ADDENDUM NO. 1

DATE: 09/16/24

Child Nutrition Kitchen
726 South Pine St.
Madera, California 93637

DARDEN PROJECT NO. 2310
City of Madera Application #19876

G000

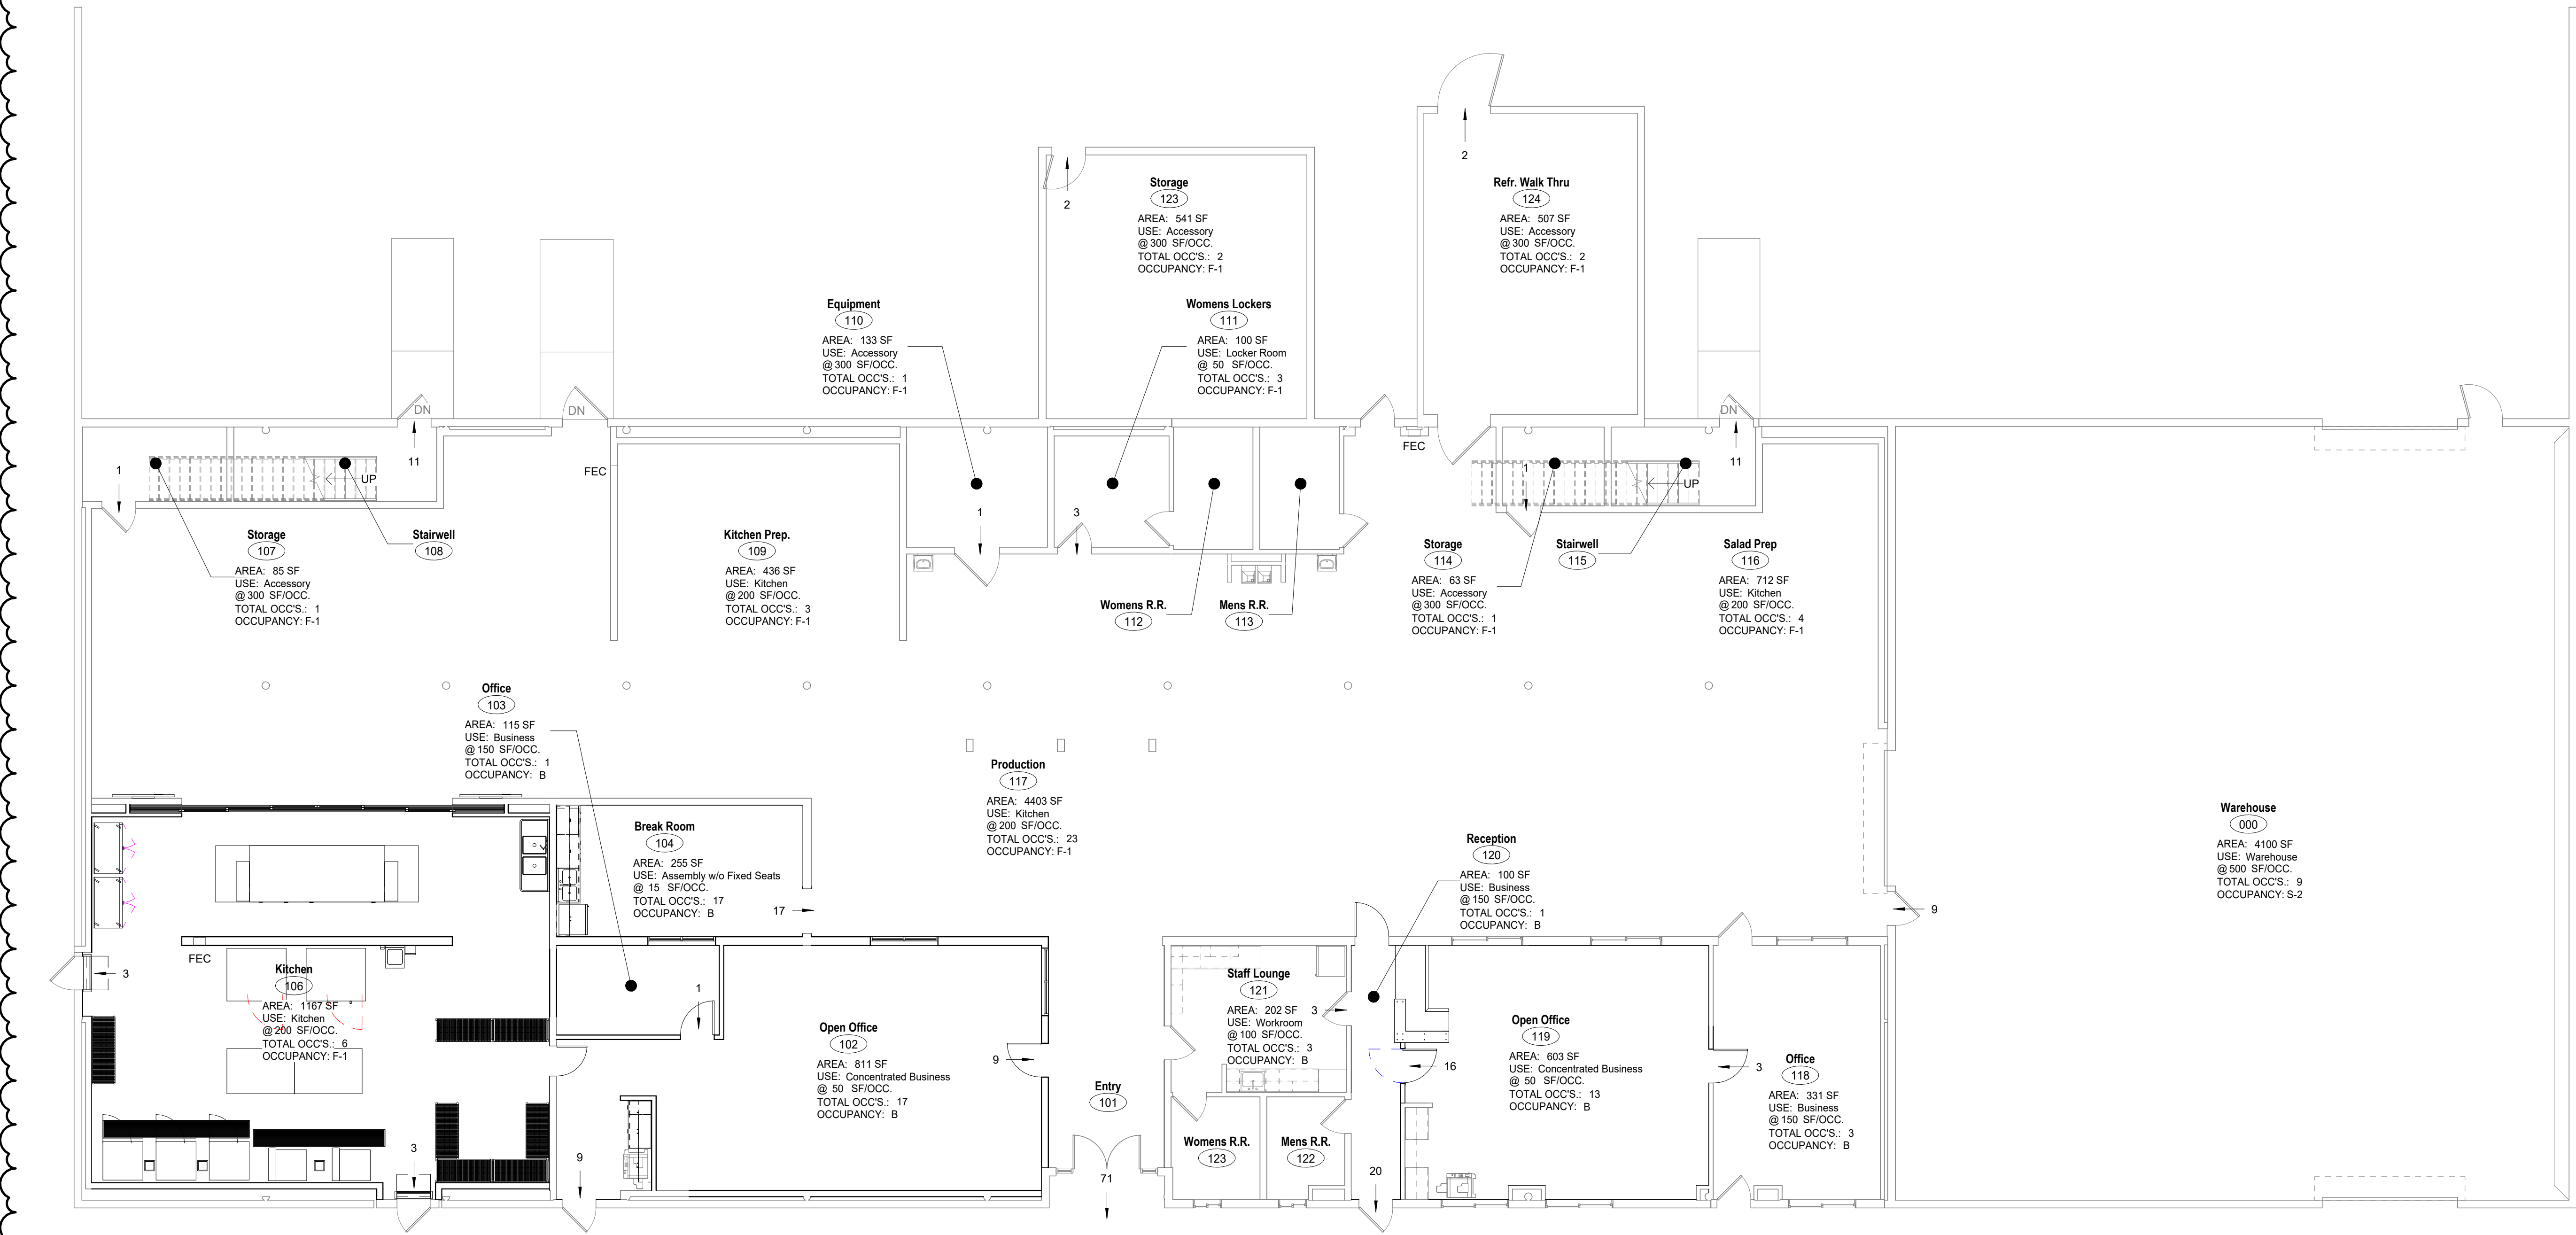
AD1-A01 Refer to Sheet G000, COVER SHEET:

1. Replace sheet with attached exhibit AD1-AX01
 - Removed references to DSA.
 - Revised years of applicable NFPA editions.

G102

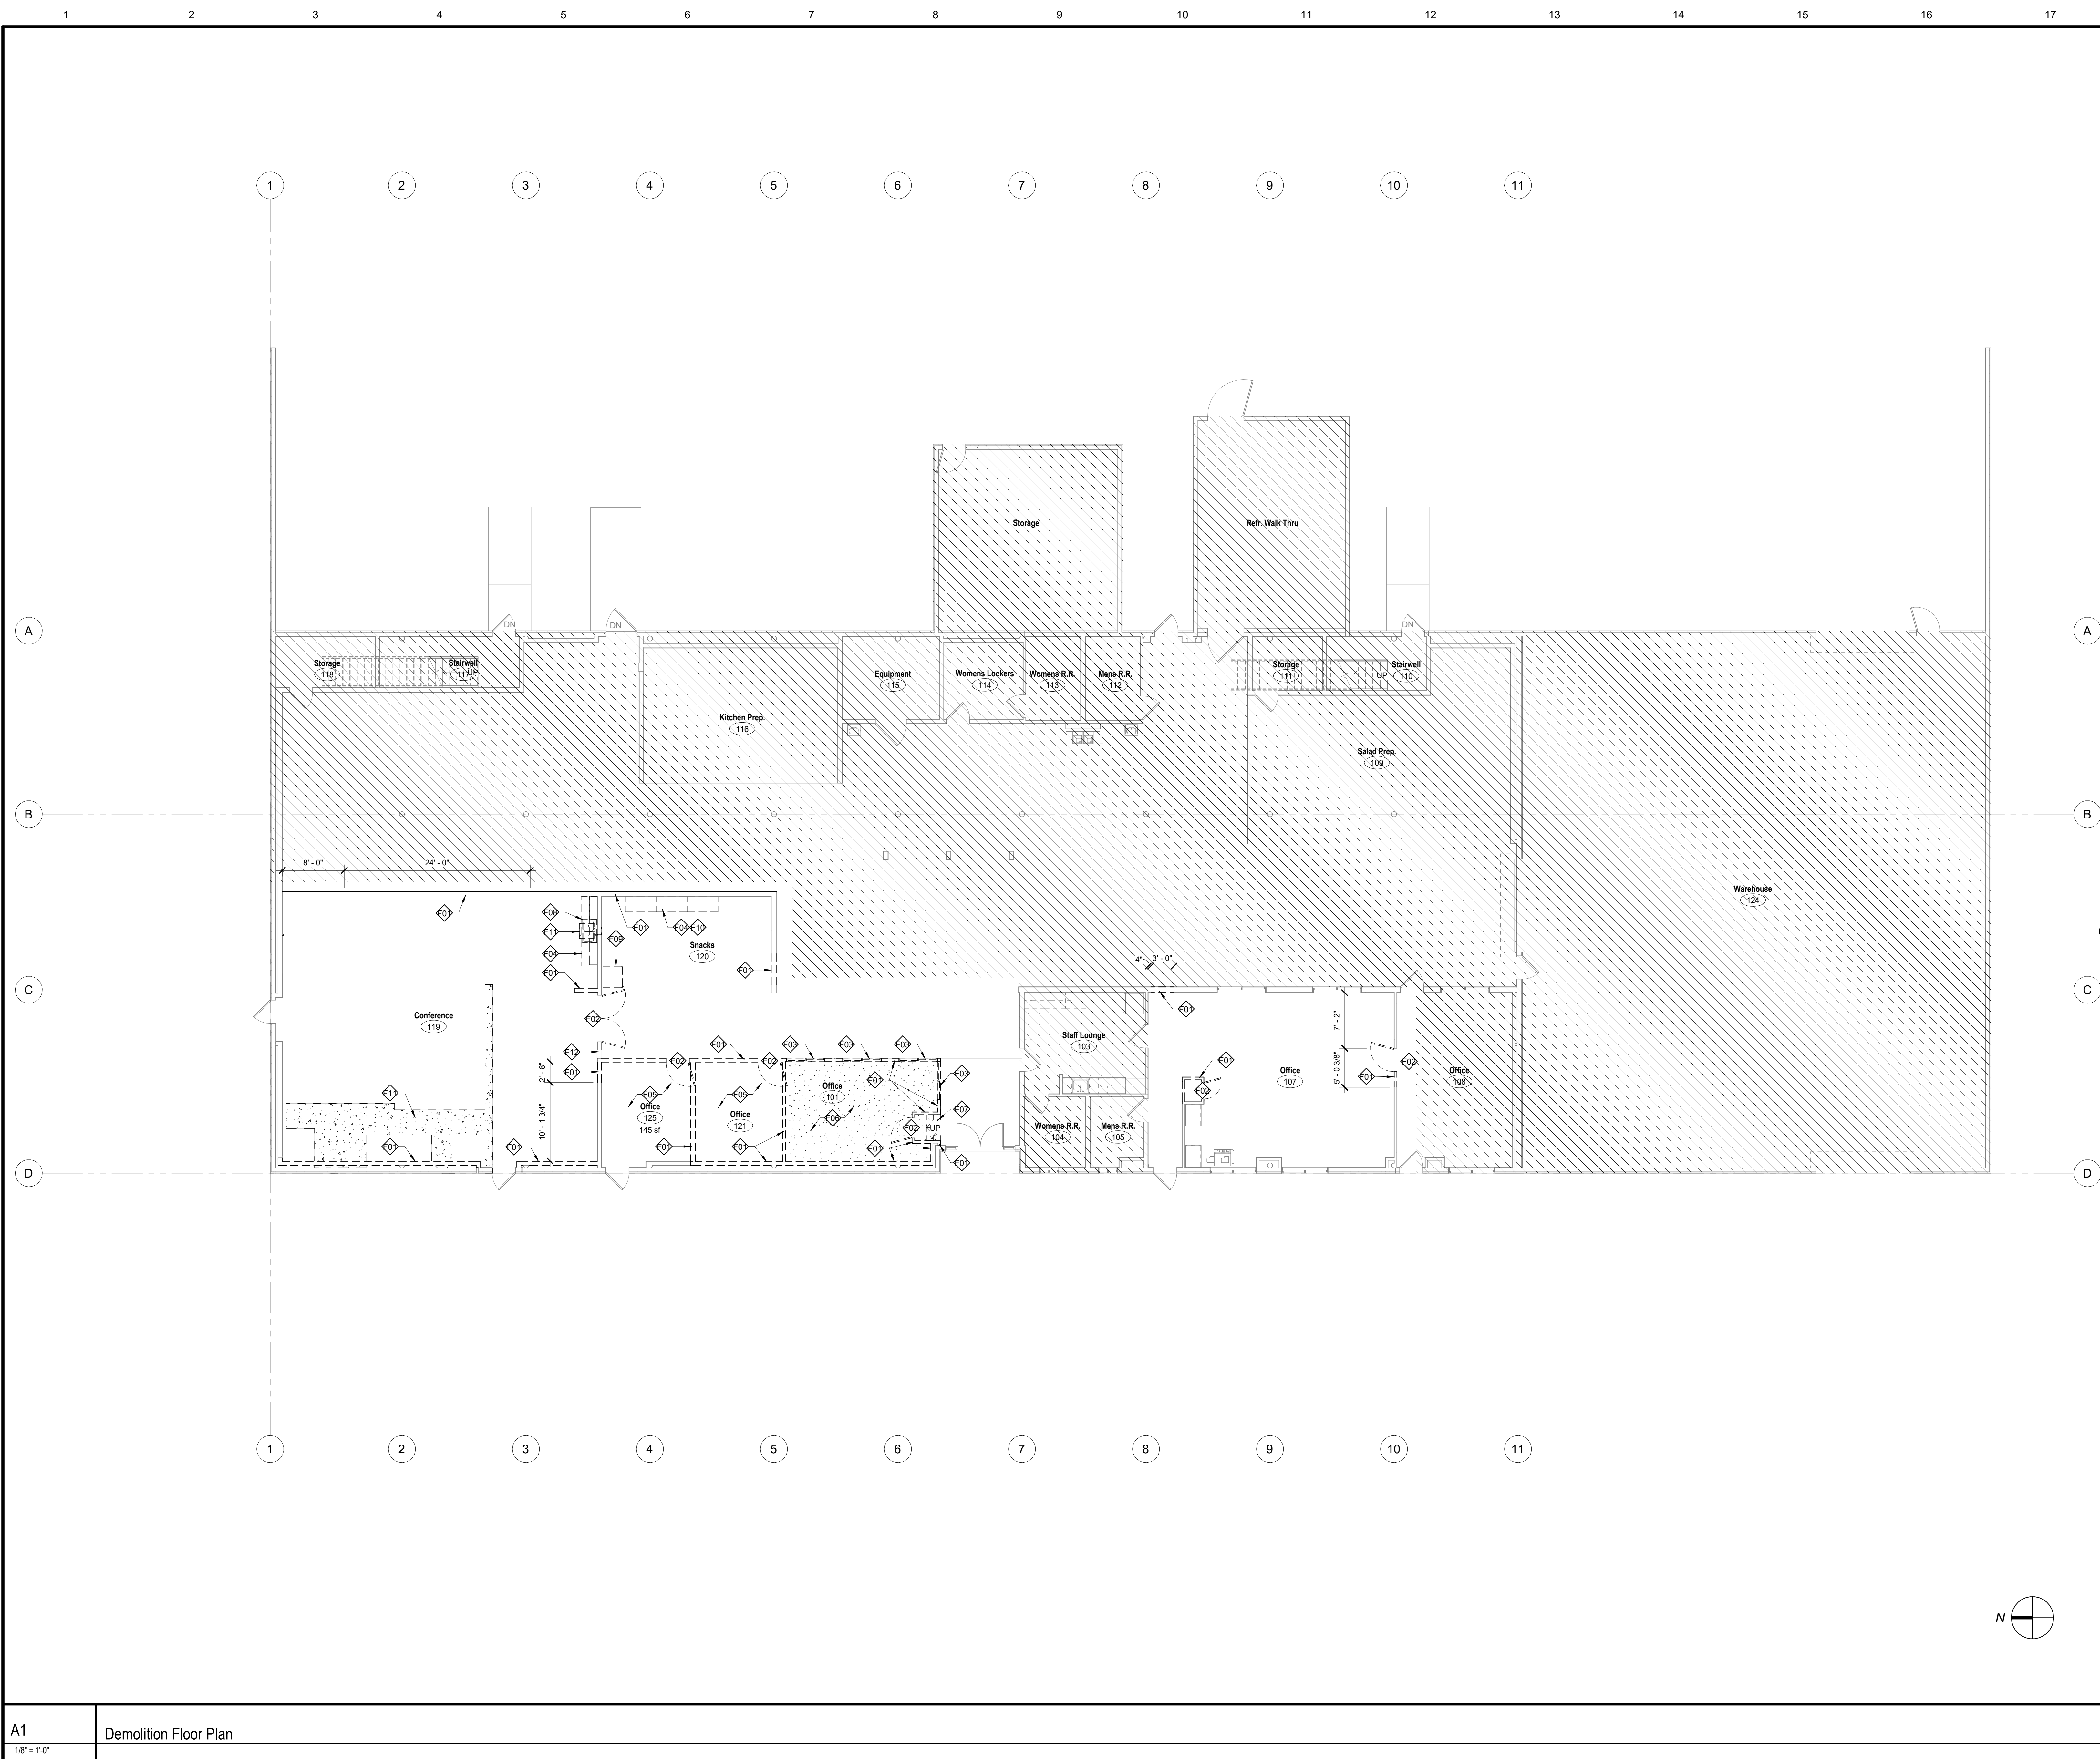
AD1-A02 Refer to Sheet G102, REGULATORY FLOOR PLAN:

1. Replace sheet with attached exhibit AD1-AX02
 - Expanded egress plan to include existing spaces.
 - Added second floor egress plan.
 - Removed building information section from legend, information exists on Cover Sheet, G000.

A/A100

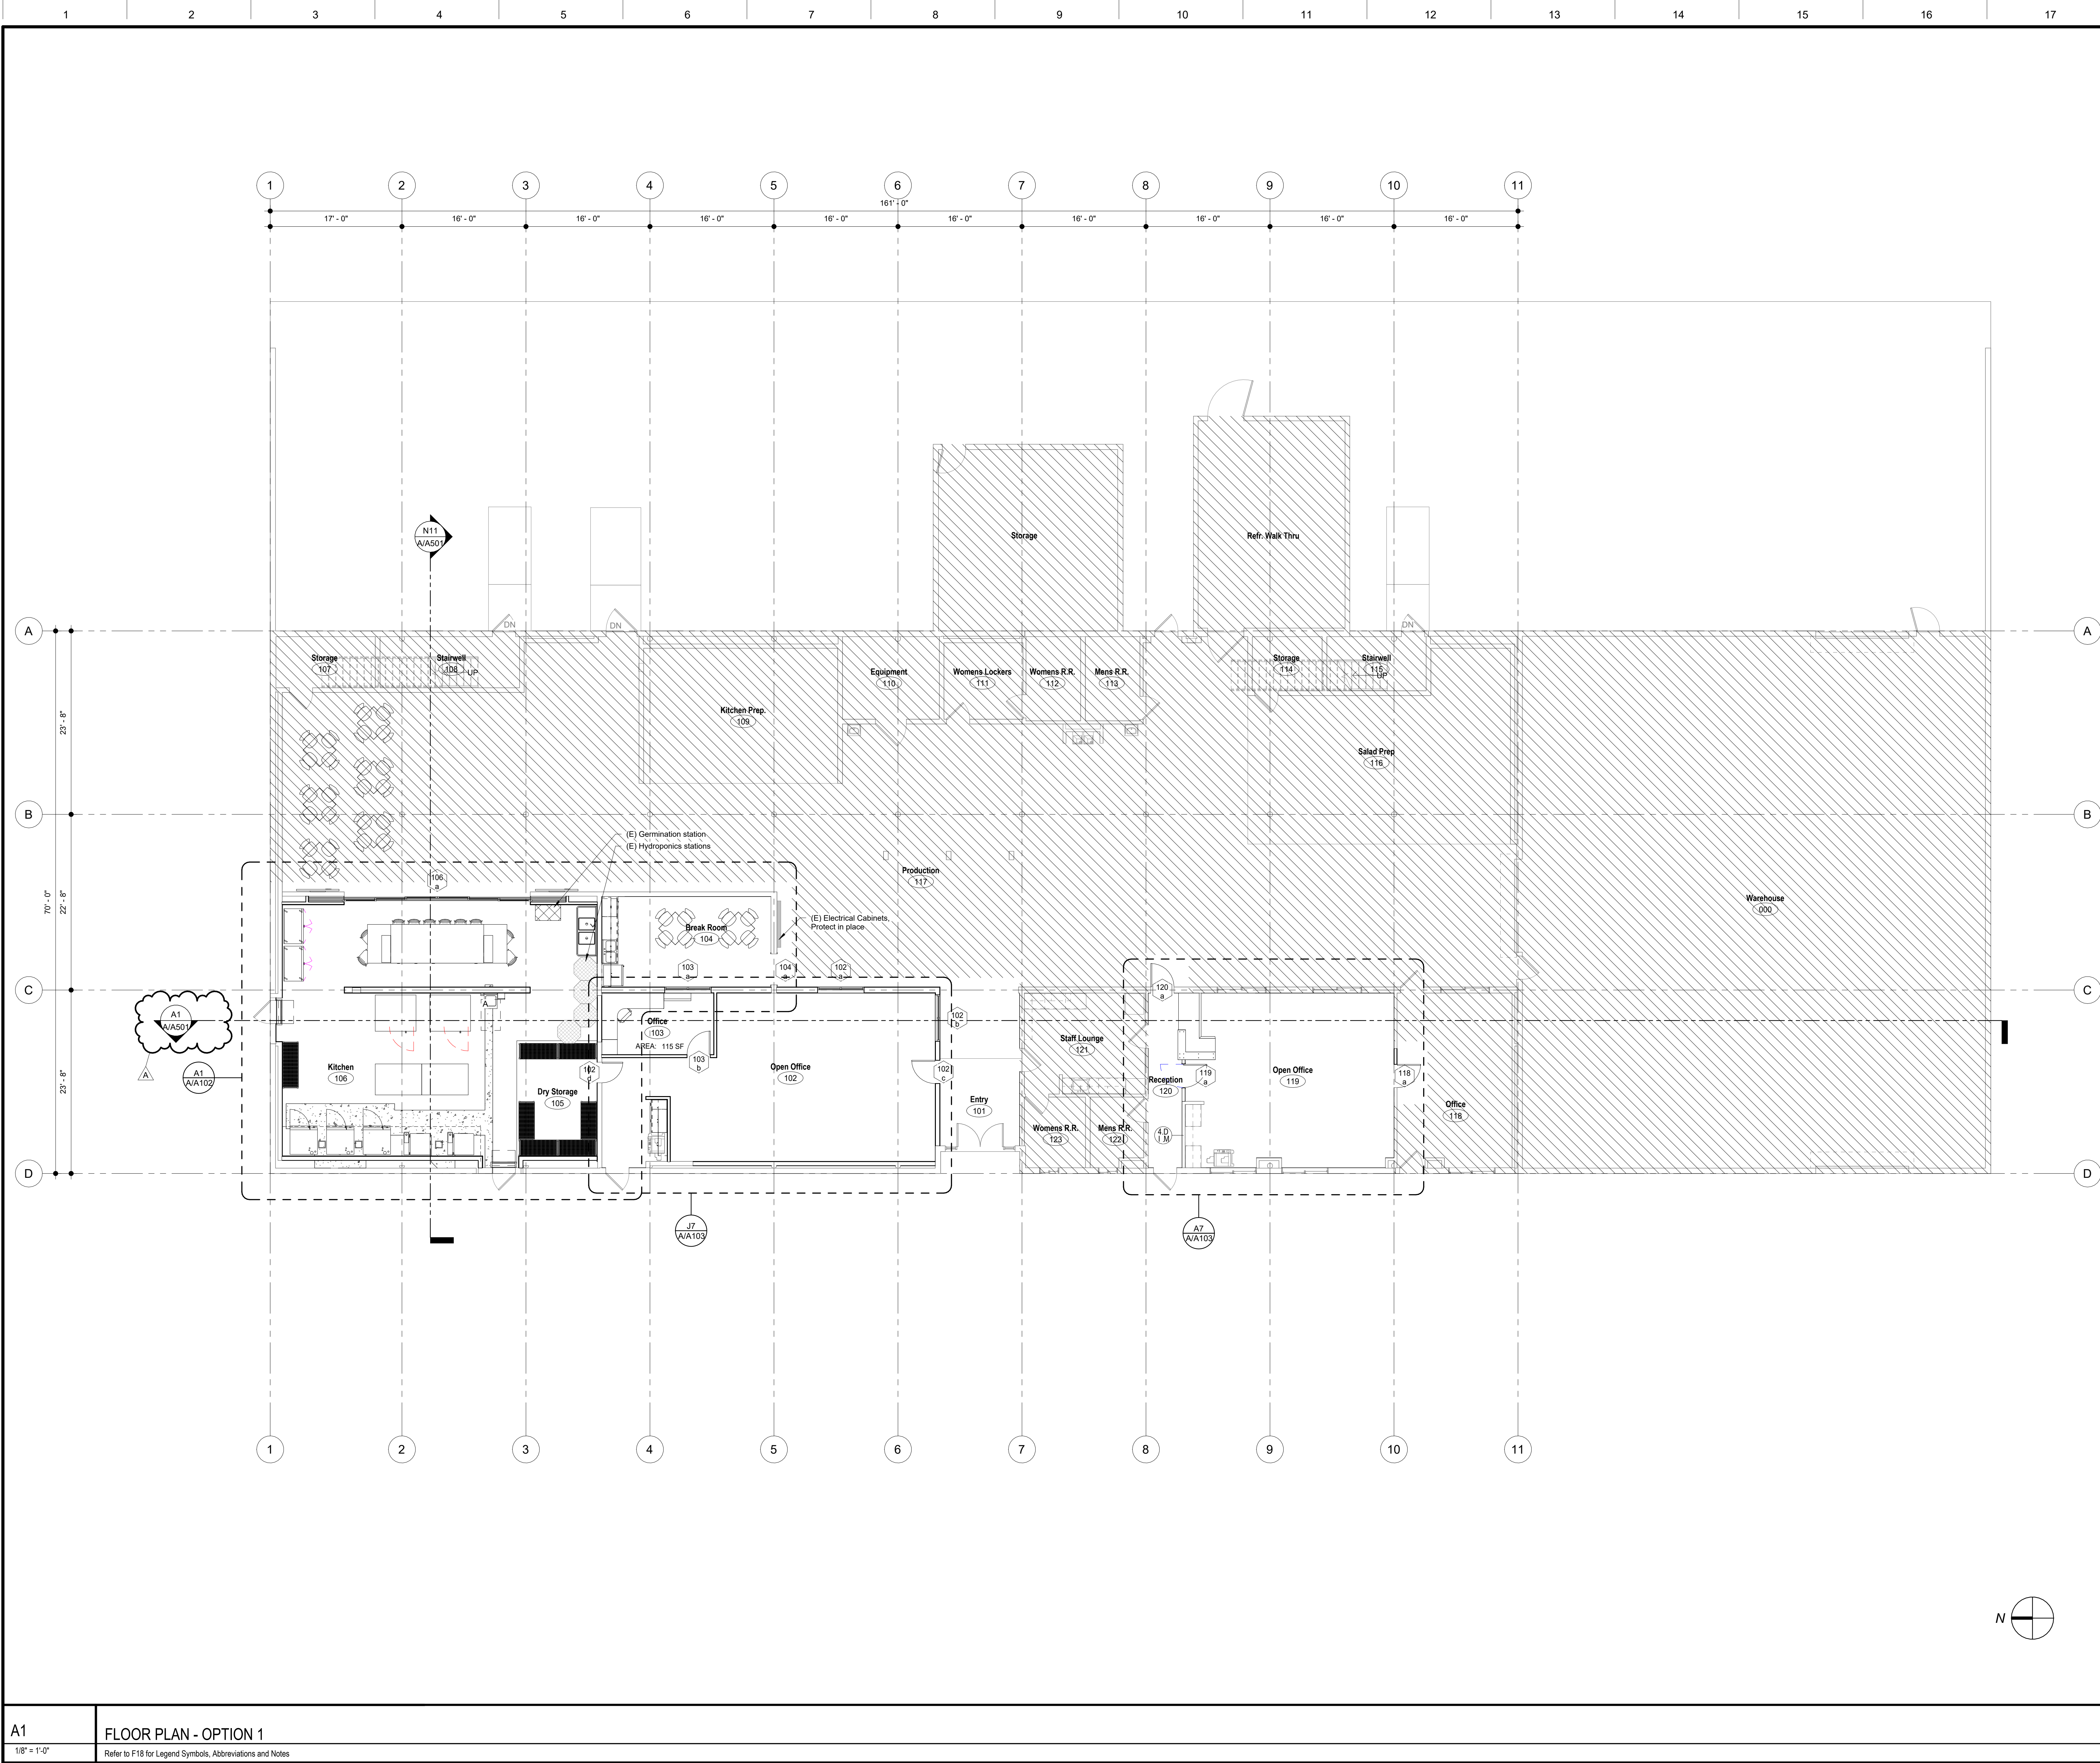
AD1-A03 Refer to Sheet A/A100, DEMOLITION FLOOR PLAN:

1. Replace sheet with attached exhibit AD1-AX03

- Key note F12 added.
